Access Compliance Report Public Rights-of-Way (Curb Ramps)

Main Street: TIGERTAIL_DR Cross Street: SILVER_FOX_RD Location: NW

ADA ID: RPRK211206173430 Ramp Type: Type 4 - Parallel Initial Pass/Fail: Fail Overall Compliance: No Severity Score: 2

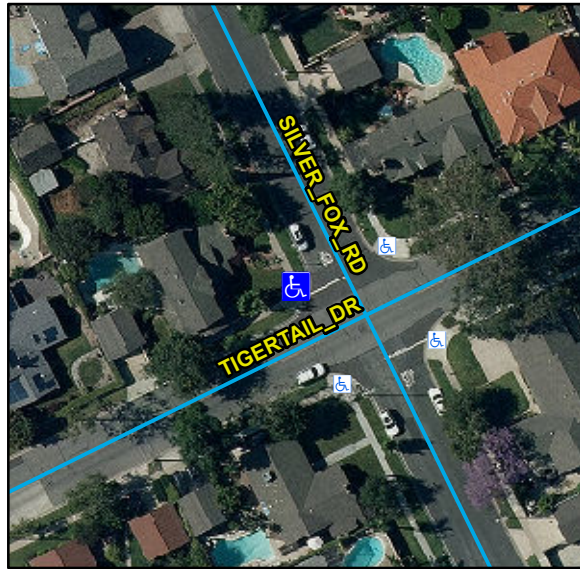
Compliance	Description	Data	Compliance	Description	Data
N/A	Ramp Length LT (in)	113	N/A	Ramp Length RT (in)	111
Yes	Ramp Width LT (in)	126	Yes	Ramp Width RT (in)	126
Yes	Ramp Run Slope LT (%)	2.8	Yes	Ramp Run Slope RT (%)	4.3
No	Ramp Cross Slope LT (%)	3.5	No	Ramp Cross Slope RT (%)	2.5
N/A	Landing Present	N/A	N/A	DWS Provided	N/A
N/A	Landing Length (in)	N/A	N/A	DWS Contrast	N/A
N/A	Landing Width (in)	N/A	N/A	DWS Length (in)	N/A
N/A	Landing Run Slope (%)	N/A	N/A	DWS Full Width	N/A
N/A	Landing Cross Slope (%)	N/A		DWS Offset Type	N/A
N/A	Landing Movement Obstructed?	N/A	N/A	DWS Offset Left (in)	N/A
	Landing Movement Type	N/A	N/A	DWS Offset Right (in)	N/A
N/A	Landing Shared	N/A			
N/A	Clear Space	Yes			
N/A	Clear Space To Crosswalk (in)	N/A			
N/A	Marked Crosswalk 1	No	N/A	Marked Crosswalk 2	No
	Crossing 1 Direction	S		Crossing 2 Direction	E
	Marked Crosswalk 1 Width (in)	N/A		Marked Crosswalk 2 Width (in)	N/A

Remove & Replace Curb Ramp With Two New Directional Ramps or Equivalent.
